Access Compliance Report

Public Rights-of-Way

(Curb Ramps)

Intersection ID: 30144	Main Street: CAGNEY_ST	Cross Street: RUMPLE_RD	Location: W
ADA ID: 341EFD2499B7	Ramp Type: Perp	Initial Pass/Fail: Fail	Overall Compliance: No
Severity Score: 8.75			
Codes/Mitigation Info/Possible Solution		Field Measurements/Component Compliance

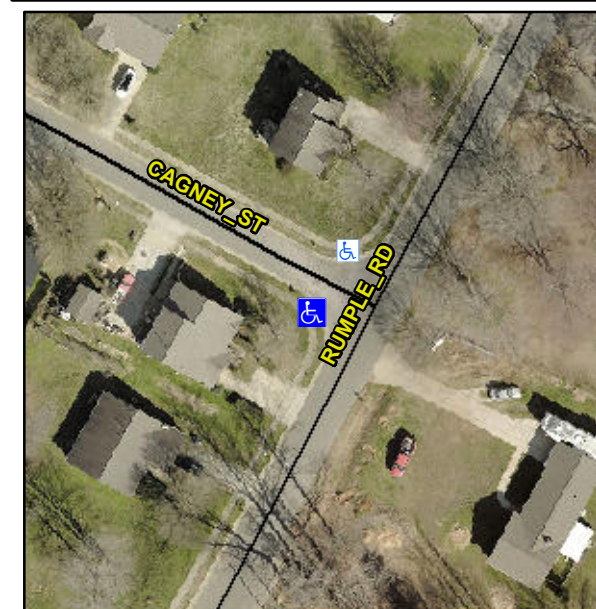
PROW/ADA:

Not Found, R304.5.1

Compliance	Description	Data	Compliance	Description	Data
N/A	Ramp Length (in)	48.0	Yes	Ramp Slope (%)	8.2
No	Ramp Width (in)	41.0	Yes	Ramp XSlope (%)	0.9
N/A	Flare Type LT	N/A	N/A	Flare Type RT	N/A
N/A	Flare Slope LT (%)	N/A	N/A	Flare Slope RT (%)	N/A
N/A	Flare Traversable LT?	N/A	N/A	Flare Traversable RT?	N/A
N/A	Landing Length (in)	N/A	N/A	DWS Provided?	N/A
N/A	Landing Width (in)	N/A	N/A	DWS Contrast?	N/A
N/A	Landing Slope (%)	N/A	N/A	DWS Length (in)	N/A
N/A	Landing X Slope (%)	N/A	N/A	DWS Full Width?	N/A
N/A	Landing Curb? (Y/N)	N/A	N/A	DWS Offset (in)	N/A
N/A	Shared Landing?	N/A			
N/A	Gutter Ponding?	N/A	N/A	Gutter Slope (%)	N/A
N/A	Gutter Lip Ht (in)	N/A	N/A	Gutter X Slope (%)	N/A
N/A	Painted X Walk1?	No	N/A	Painted X Walk2?	N/A
	X Walk 1 Direction	To NE		X Walk 2 Direction	N/A
N/A	X Walk 1 Width (in)	N/A	N/A	X Walk 2 Width (in)	N/A
	X Walk 1 Slope (%)	1.5		X Walk 2 Slope (%)	N/A
	X Walk 1 X Slope (%)	0.7		X Walk 2 X Slope (%)	N/A

Possible Solutions:

Remove & Replace Entire Ramp.
